CELINA WASTEWATER TREATMENT PLANT SLUDGE DEWATERING IMPROVEMENTS

POSTED FOR RECORD DOCUMENT

OWNER: CITY OF CELINA 0856-003-01
 PROJECT: WWTP Sludge Dewatering Improvements
 CONTRACTOR: Meta Contracting, Inc.
 ENGINEER: Alan Plummer Associates, Inc.
 FIELD ORDER NO.: FO-001 DESCRIPTION: WAS PS Slab Conflict

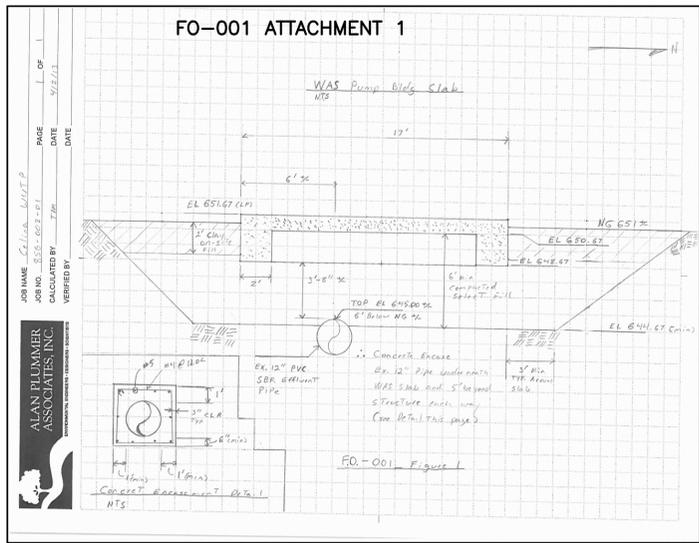
- 1) Location of WAS Pump Station slab shall be as indicated on the plans.
- 2) Concrete encase the portion of the existing 12" SBR effluent pipe under the WAS PS slab and to 5-ft beyond the edge of slab in each direction.
- 3) Concrete encasement and reinforcing steel shall be per the detail attached to this FO (Figure 1). Concrete shall be a minimum of 3000 psi.
- 4) Back fill and connection can begin after the concrete has cured 7 days or reaches 2/3 strength.
- 5) The existing pipe is an active gravity flow pipe under surcharge (pressure) conditions. The contractor shall protect and support the pipe from puncture, leakage and distortion at all times.

OWNER: CITY OF CELINA 0856-003-01
 PROJECT: WWTP Sludge Dewatering Improvements
 CONTRACTOR: Meta Contracting, Inc.
 ENGINEER: Alan Plummer Associates, Inc.
 FIELD ORDER NO.: FO-002 DESCRIPTION: Sludge Dewatering Building Drain Lines Slope

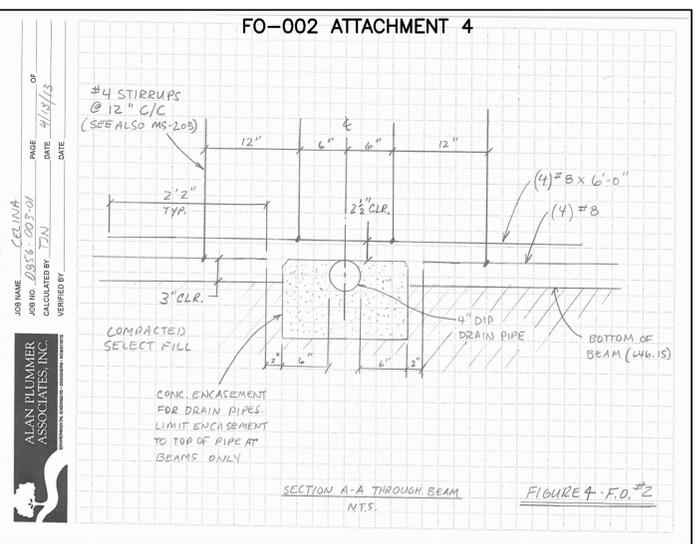
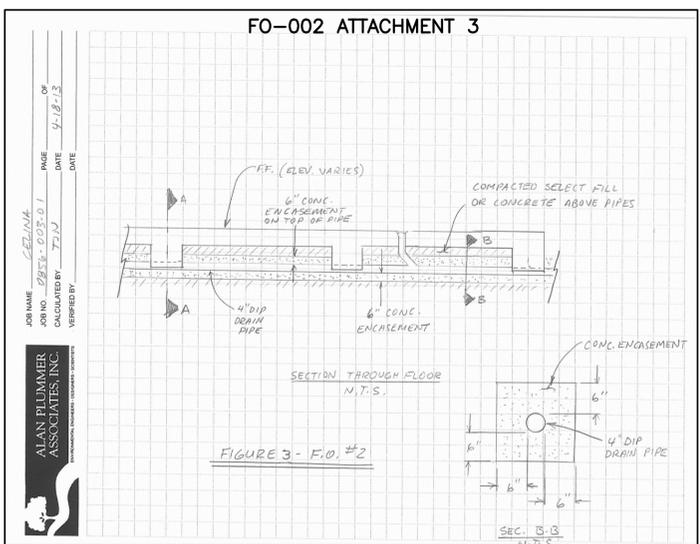
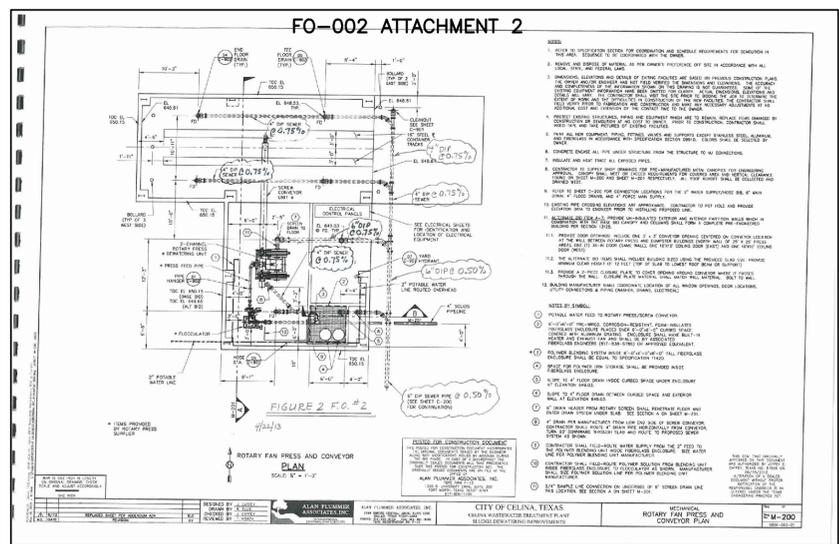
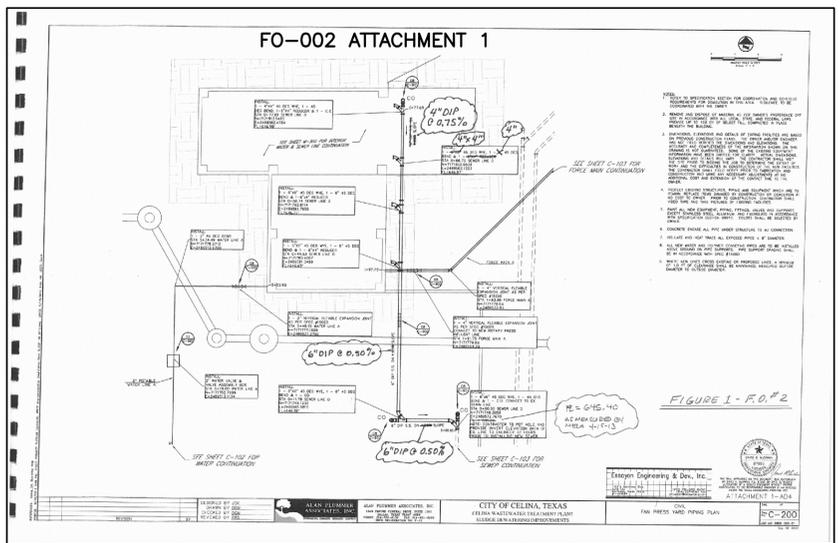
- 1) Slopes of the gravity drain lines shall be installed as follows:
 - a) The 4" DIP from STA 0+00.00 (main point) to STA 0+56.74 of Sewer Line D shall be installed on a 0.50% slope. See Figure 1.

- b) The 4" DIP from STA 0+56.74 to STA 0+77.69 of Sewer Line D shall be installed on a 0.75% slope. See Figure 1.
 - c) The 4" DIP lateral from STA 0+44.53 of Sewer Line D to the floor drain and drain for the press screw conveyor shall be installed on a 0.75% slope. See Figure 2.

- d) The 4" DIP lateral from STA 0+44.74 of Sewer Line D to the floor drain and drain for the rotary screen unit shall be installed on a 0.75% slope. See Figure 2.

- e) The 4" DIP lateral from STA 0+49.78 of Sewer Line D to the floor drains shall be installed on a 0.75% slope. See Figure 2.
 - f) The 4" DIP lateral from STA 0+77.69 of Sewer Line D to the floor drains shall be installed on a 0.75% slope. See Figure 2.

- 2) The lateral drain pipes shall be concrete encased as shown in Figure 3. In between the beams, the material installed above drain line encasement shall be compacted select fill or concrete, at the discretion of the Contractor.

- 3) In the areas where the drain lines interfere with the slab beams, the beam reinforcement shall and drain line concrete encasement shall be installed as shown in Figure 4.
